REPORT OF THE PANEL
ON
EVALUATION OF GROUND-WATER FLOW IN FRACTURES
AT
THE PALO DURO BASIN

The stated charge addressed in this report is to assess the relative importance of, and availability of data to evaluate the fracture contribution to ground-water flow at the Palo Duro Basin sites in Texas. In arriving at our conclusions, the panel has reviewed pertinent publications, has been presented information from various participating contractors, and has had an opportunity to question these contractors. On the basis of these inquiries, we have developed our own conceptual model of ground-water flow along with the possible relevance of fractures within this conceptual framework.

FIGURE 1. Hypothetical schematic fracture styles considered by the panel for ground-water flow in the evaporite section of the Palo Duro Basin.

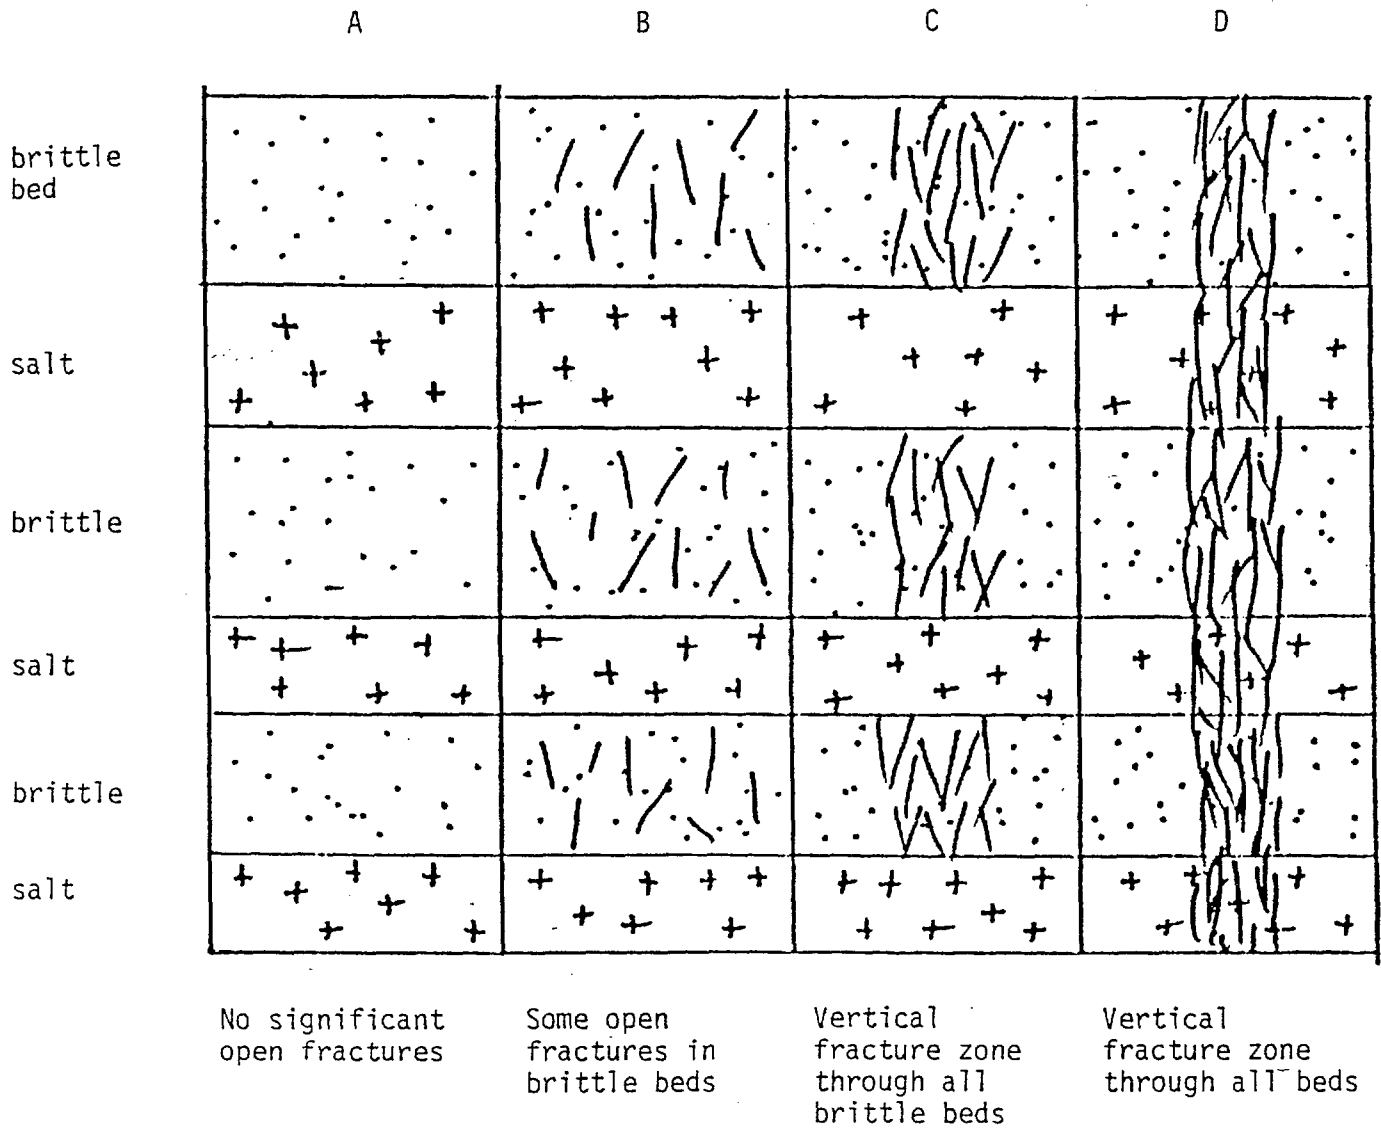
Depicted in Figure 1 are simplified examples of fractured and porous flow conditions that could be included in a Monte Carlo model. We consider Case A, a condition of non-fractured porous flow to be the expected or the most probable condition in the Palo Duro Basin. Probability distributions on the hydraulic parameters should be sufficiently general to account for some dispersed, low intensity fracturing in what we term the brittle or non-salt units. This type of fracturing (depicted in Case B, Figure 1) should not necessarily be correlated between geologic units. Case C represents fracturing associated with structural discontinuities that may be propagated, from the basement, upward to the ground surface. More specifically, this fracturing probably involves fracture flow through the non-salt units and porous flow through the salt units (Figure 1 and 2). Travel times calculated along this pathway, if possible, should include times for movement along mainly porous pathways (Cases A and B) to the vertical discontinuities. The actual position of this vertical zone should be treated as a random variable. Because this total travel path is thought to occur infrequently in the Palo Duro Basin, its contribution to the overall travel time distribution should reflect this low probability of occurrence.

Case D (Figure 1) is a situation where conditions of fracture flow are propagated along the entire length of a structural discontinuity. From our examination of the available data for the basin, we do not feel that

a case can be made at this time for the existence of this kind of pathway in the basin. Thus, we would recommend that Case D not be included in the Monte Carlo analysis.
